Subject: Reduced Seismic Criteria at Commonwealth Edison Nuclear Facilities

RESPONSE TO NRC QUESTIONS ASKED AT APRIL 28, 1994
ComEd/NRR MEETING

**ComEd Response to NRC Questions asked at
April 28, 1994 ComEd/NRR Meeting**

Figure 1-1

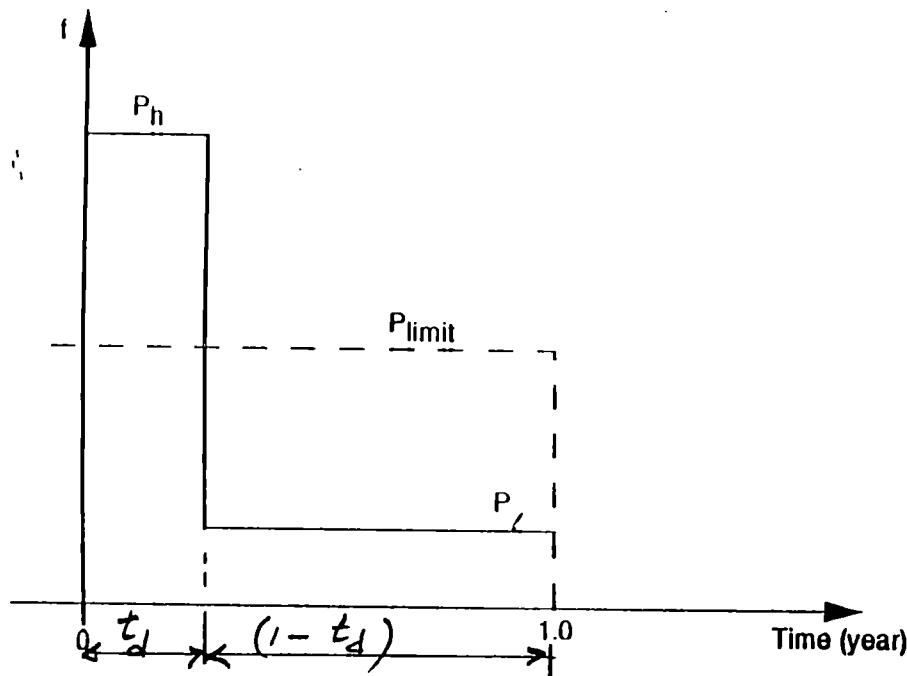
Dr. C. Allin Cornell, in his third party review of ComEd's scale factors has found them to be acceptable. However, Dr. Cornell chose to calculate these factors using a risk averaging method. This method is described in Dr. Cornell's letter of April 25, 1994. Figure 1-1 shows an illustration of the risk averaging concept. Table 1-2 compares the scale factors determined by risk averaging versus the results from the constant probability approach. We conclude that Dr. Cornell's alternative approach does not result in an accurate determination of comparative risk for the following reasons:

To obtain the comparison shown in Table 1-2, the following values are used for the parameters in Figure 1-1:

$$P_{\text{limit}} = 2p_{SSE}$$

$$P_1 = p_{SSE}$$

p_h = as determined from risk averaging

The parameter $p_{\text{limit}} = 2p_{SSE}$ is particularly significant. It shows that ComEd scale factors is associated with a frequency of exceedance per year that is smaller than $2p_{SSE}$, (because risk averaging scale is smaller than ComEd scale factors at $p_{\text{limit}} = 2p_{SSE}$).
